C/ 00	SC 00	P 00	L 00	# 151
Gubbi, Raj	ugopal	Independent

Remove MCTA scheme from the standard ref: CID 536 - LB12, CID 513 - LB19, and CID 63 - LB22. Why can't the open and association be performed in CAP instead of devicing a new mechanism altogether for such a relatively low probability events? what is the point in having another collision based access mechanism inside a declared "collision free period (CFP)". If the concern is about a new PHY that may be added in the future, this mechanism can be added at the time of including the new PHY as allocations to a currently reserved stream ID (or DEVID) so that the legacy DEVs keep off of those slots and the new DEVs use them as per the new rules.

SC 7.3.1.1, Figure 13

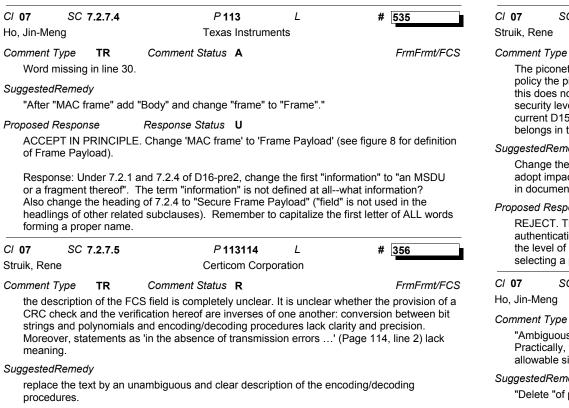
policy the piconet adh this does not sufficien security level at which current D15 draft cont	should indicate in its piconet eres to. Currently, it only indic tly indicate other security char access control in the piconet ained in the Security Requirer mode field and should be mo	ates whether s racteristics, suc is arranged. Th ments Field (se	ecurity is ON or OFF, but th as the minimum bit- his information, in the		
lefinition	SuggestedRemedy					
/ISDU ?		text to accommodate for this oth in Clause 7.3.1.1 and in C				
ne L words	Proposed Response	Response Status W				
	authentication respons	ation is already passed to DE se command. While it allows t his provides only part of the in	he DEV to know	w before it joins what is		
=rmt/FCS	C/ 07 SC 7.3.2.2	P 119	L	# 545		
sion of a	Ho, Jin-Meng	Texas Instrur	ments			
een bit n.	Comment Type TR	Comment Status R		ACK/Dly		
!) lack	"Ambiguous specification in line 50: What does "frames of pMaxFrameSize" mean? Practically, the recipient DEV has to assume that the frames to be sent are of maximum allowable size in setting the value for the Max Burst field."

Incorrect illustrations in Figure 119 and Figure 120.

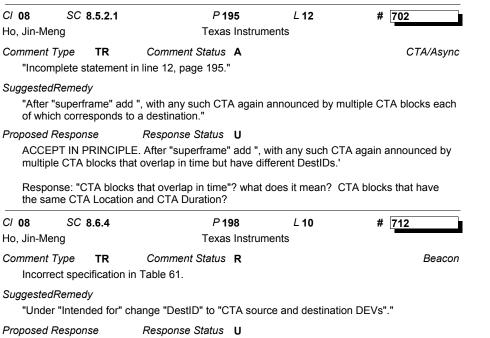
"Change "ACK" to "Imm-ACK" in both figures. Change "ResultCode" to "ReasonCode" in each of these two figures (recall that the actual result is encoded in the ReasonCode)."

ACCEPT IN PRINCIPLE. Change "ACK" to "Imm-ACK" in both figures. Change "SUCCESS" to "RESPONSE\_RECEIVED" in each of these two figures. Ed. Note coordinate this code with new clause 6 name.

Response: Check against clause 6 that it is "RESPONSE\_RECEIVED" but not "COMPLETED".

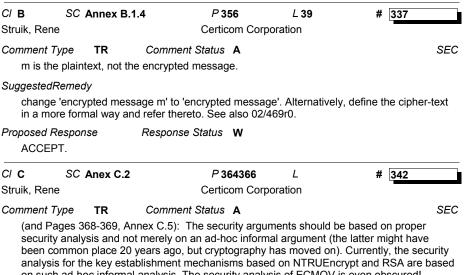
Suggested remedy: use lowest-order bit last conventions everywhere throughout all security specifications (e.g., 802.11 does this.)

Proposed Response Response Status W ACCEPT.
